Access Compliance Report

Public Rights-of-Way (Curb Ramps)

Intersection ID: 28159	Main Street: CRUDEN_BAY_WY	Cross Street: JAMES_RICHARD_DR	Location: NE
ADA ID: EA0D81DEC0B7	Ramp Type: Perp	Initial Pass/Fail: Pass	Overall Compliance: No
Severity Score: 0			
Codes/Mitigation Info/Possible Solution		Field Measurements/Component Compliance

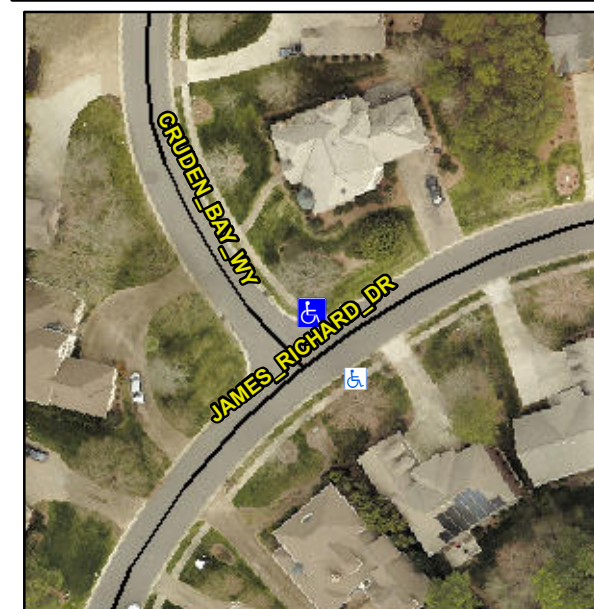
**Remove & Replace Detectable
Warning System.**

R305.2
